SUBJECT: Amendment to Nuclear Regulatory License Numbers SNM 1446 and BML  
 02-09090-02

2. This amendment is for the temporary removal of two sections of hurricane fence as shown on the attached diagram (encl 1). This removal is necessary to allow access to the area by machinery during the construction of a building addition. The sections are comprised of a 13 foot length and a 40 foot length forming the "L" shaped portion of the perimeter outside the southwest wall of building 12508, where the radioactive sources are stored and used. We will erect a temporary 40 foot chain-link fence as shown on the diagram, and it will remain for the duration of the construction, expected to take approximately 1 year. The temporary fence will contain a "Caution Radiation Area" sign similar to the one presently mounted on the existing fence. At the end of the construction phase, we will reinstate the original 8 foot fence at its present location, and remove the temporary fence.

Incl 1

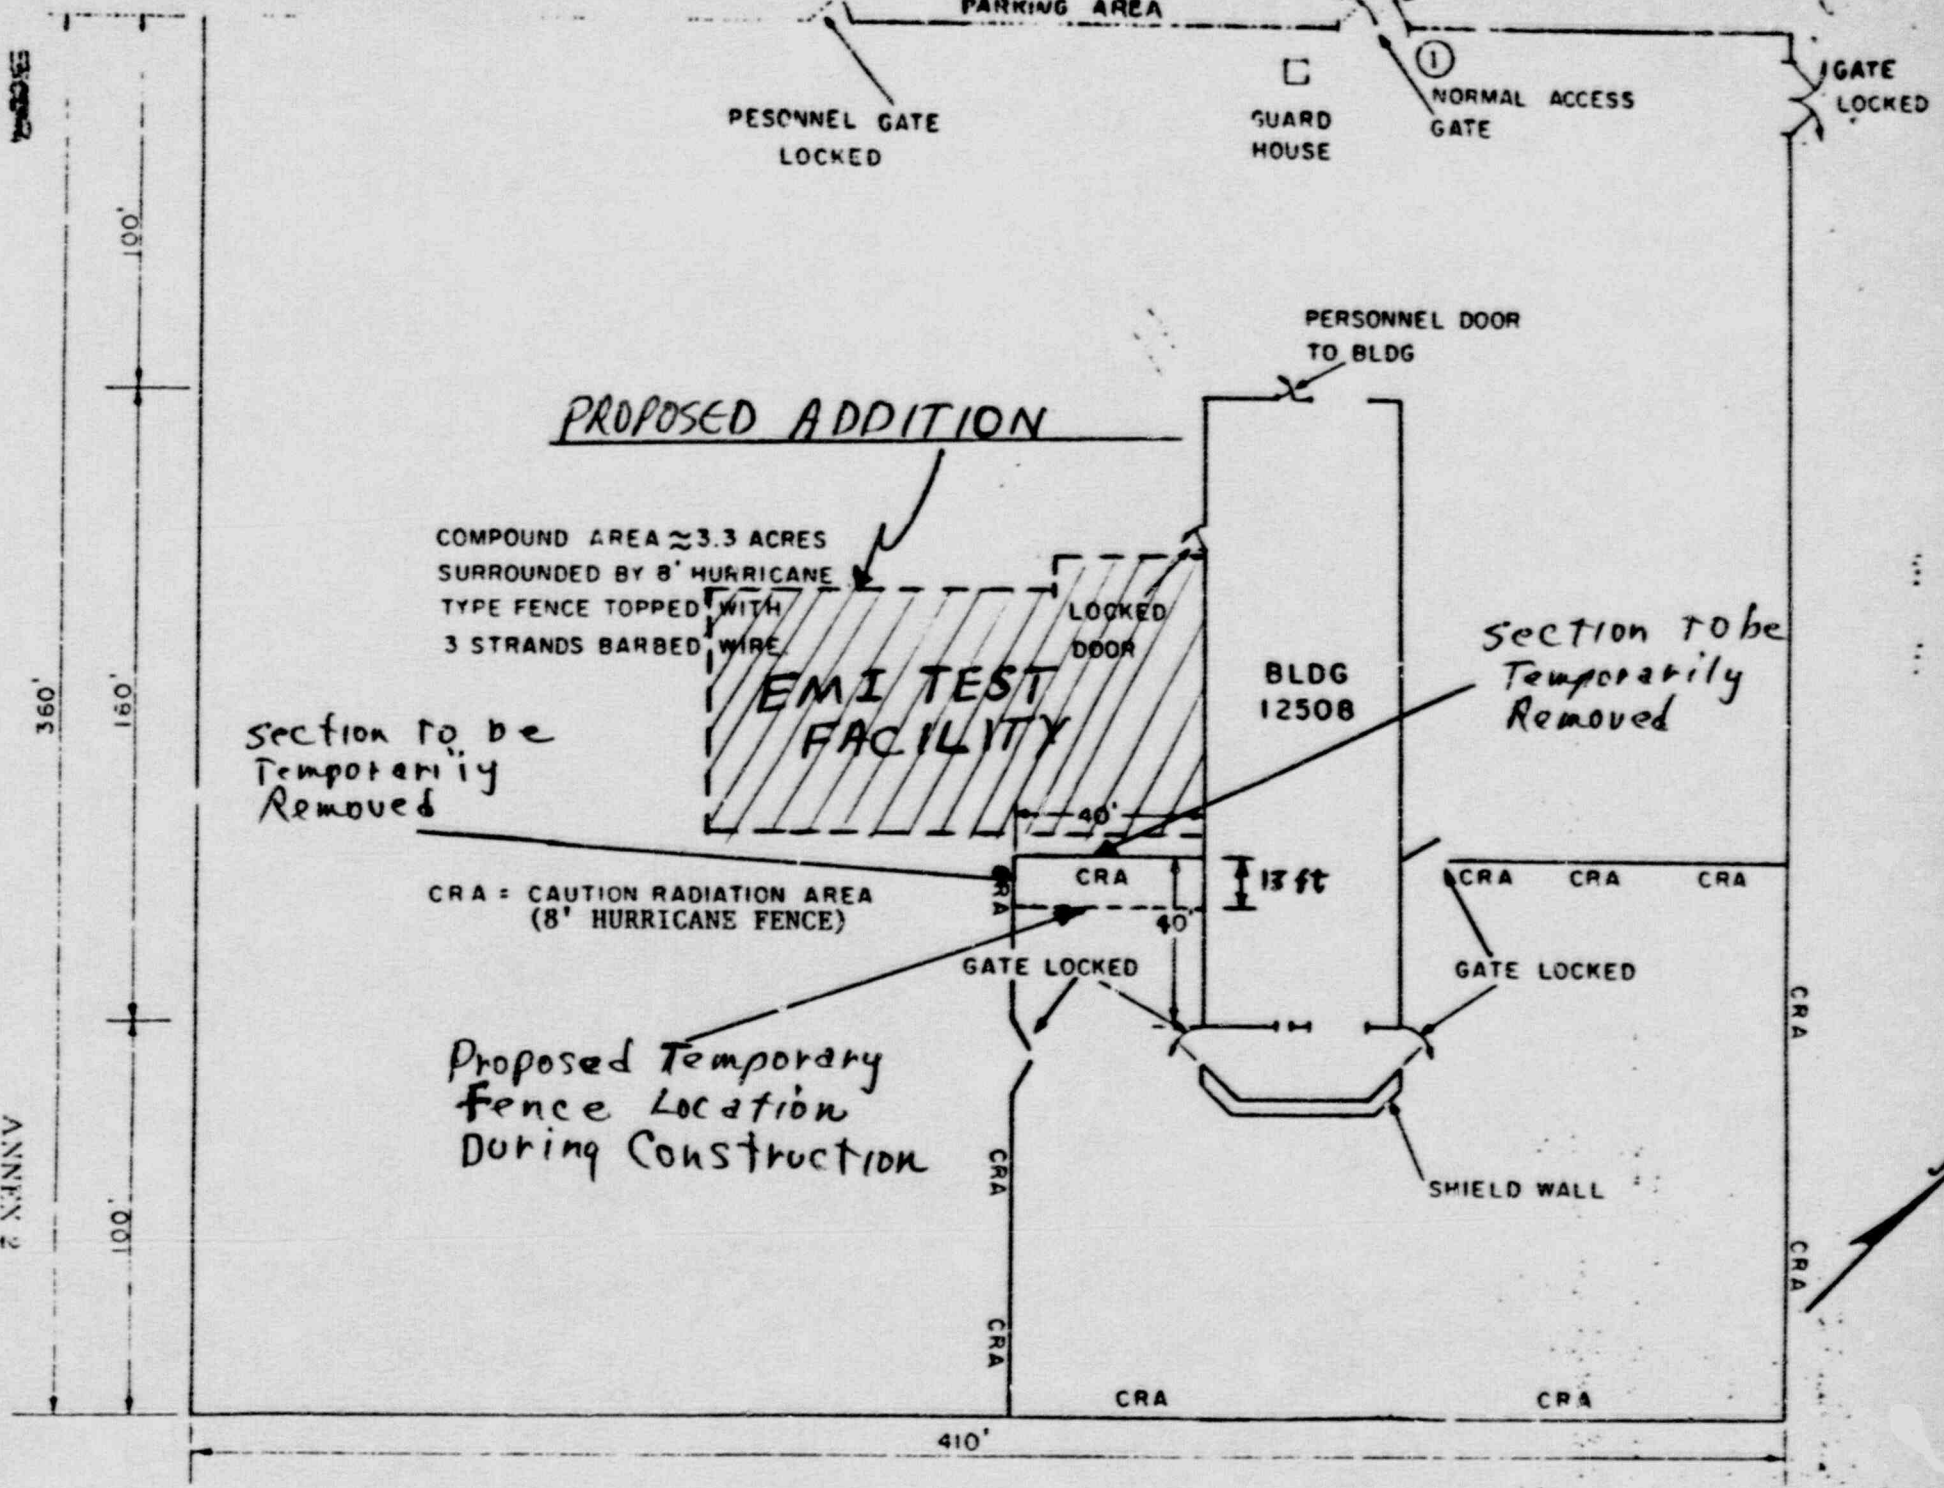
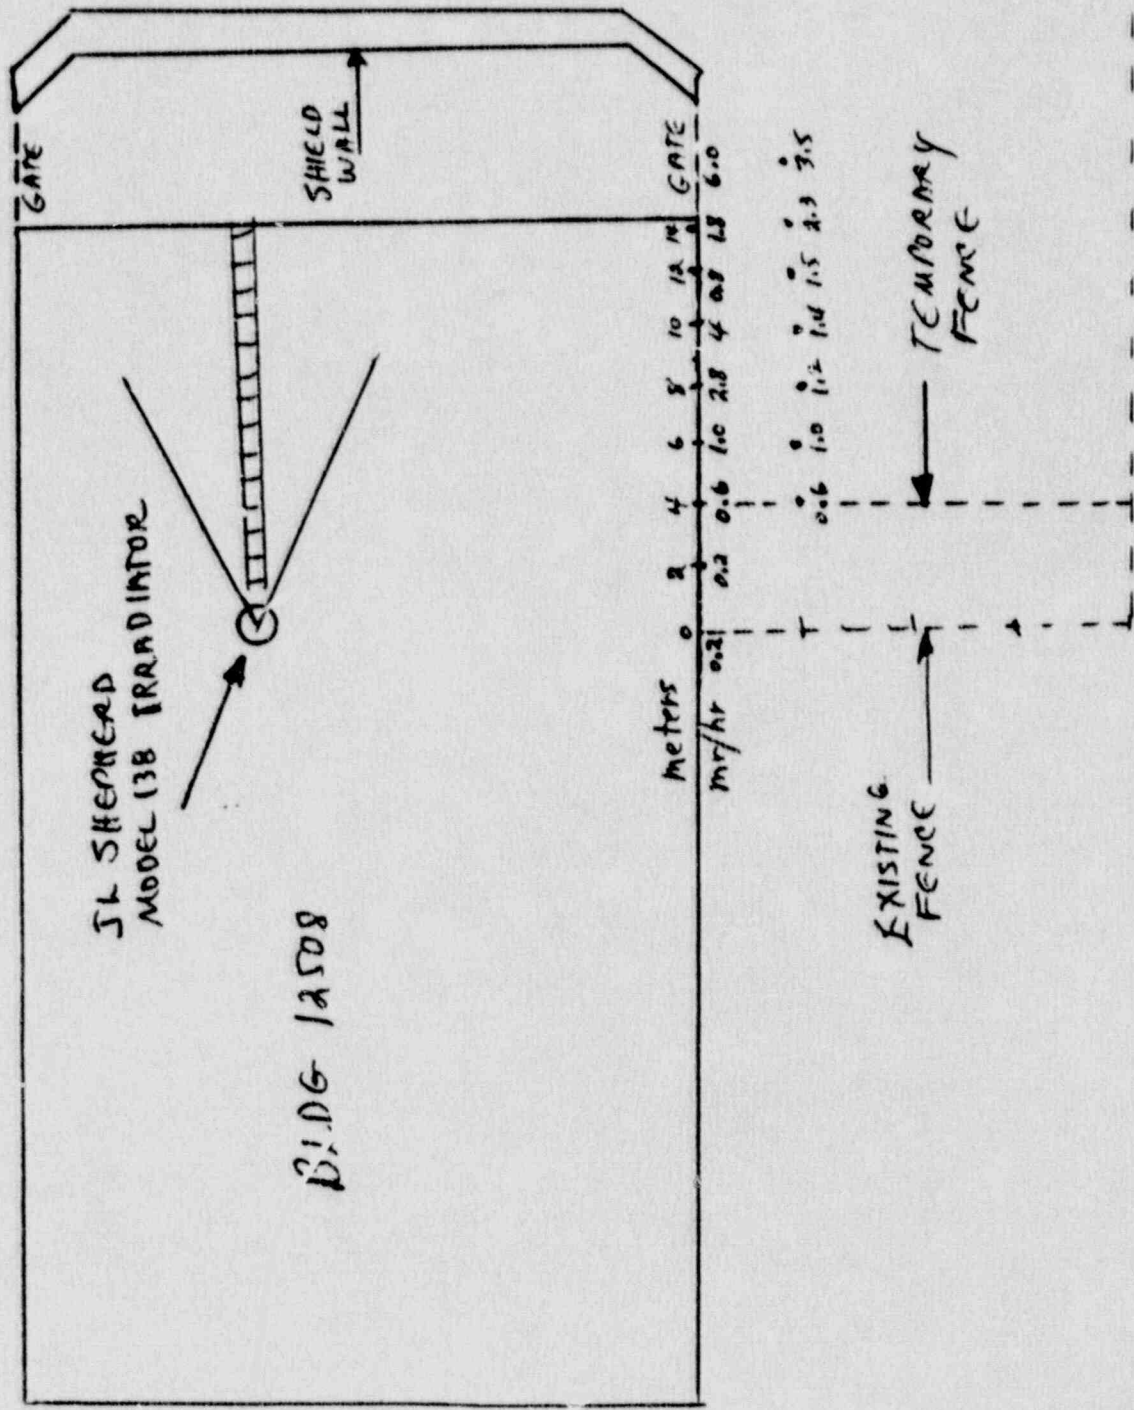
Section to be Temporarily Removed

Section to be Temporarily Removed

Proposed Temporary Fence Location During Construction
